EclA Addendum and Outline Bat Sensitive Lighting Strategy

Land South of Ashford Road, Sellindge

July 2024

This Technical Note has been prepared by CSA Environmental on behalf of Gladman Developments Ltd. in response to comments received from the Kent County Council (KCC) Ecological Advice Service (EAS) (dated 29.05.2024 and 18.07.2024) in relation to proposals for residential-led development at 'Land South of Ashford Road, Sellindge' (Folkestone & Hythe District Council (FHDC) Planning Application Reference: 20/0604/FH), hereafter referred to as 'the Site'. Ecological information submitted to date alongside the application has been in relation to habitats, bat activity, breeding birds and reptiles. A desk-based assessment was made for great crested newts and a subsequent application for a District Level Licence (DLL) was made. KCC EAS comments have been provided in relation to these submitted documents. This Technical Note responds to those comments and updates the ecological impact assessment in response to design changes and additional survey information.

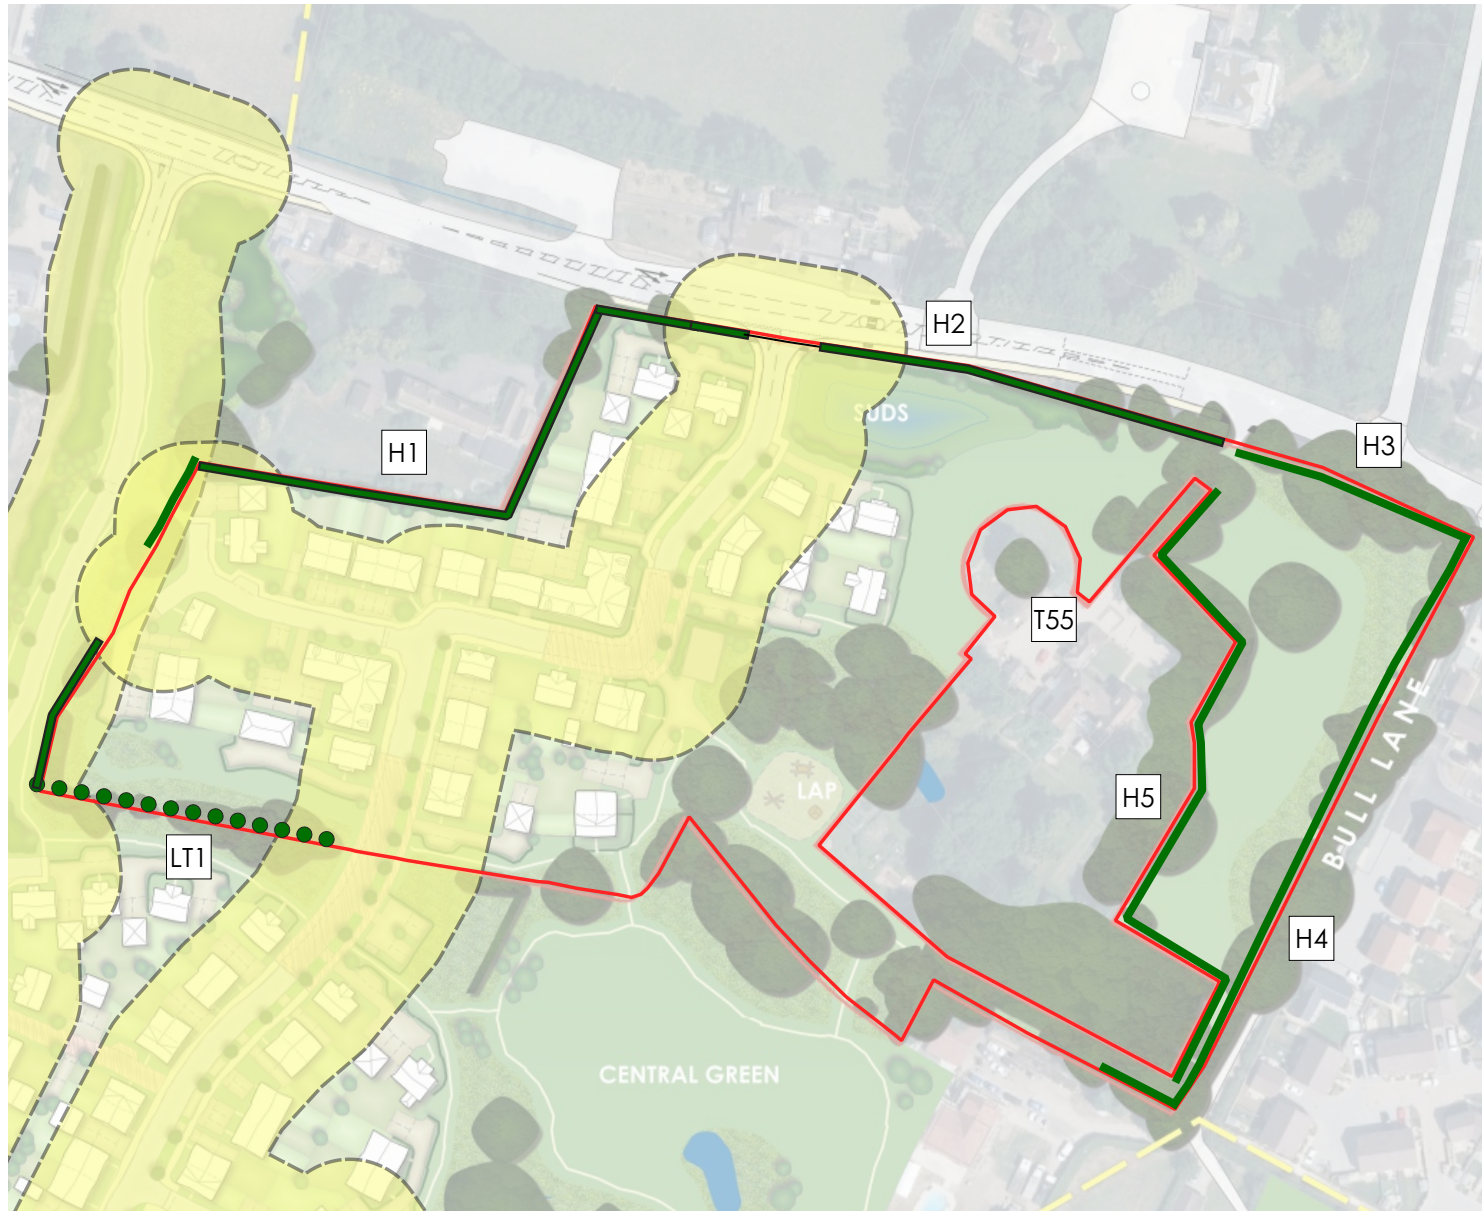
- 1.12 This potential impact will also be limited in severity due to the extent of the development area and retention of preexisting foraging areas, as shown on the DFP (CSA/4509/122/E), which are known to be the areas on site most used by bats (See Figure 1 below, taken from the Bat Survey Report in the EclA CSA/4509/06/Rev C). It is also fair to acknowledge that no significant bat activity was recorded at the boundaries between application sites, indicating that this area does not constitute an important flight path for bats. As such, the above request for further surveys triggered by 'unavoidable impacts', is not considered reasonable or proportionate at this stage.
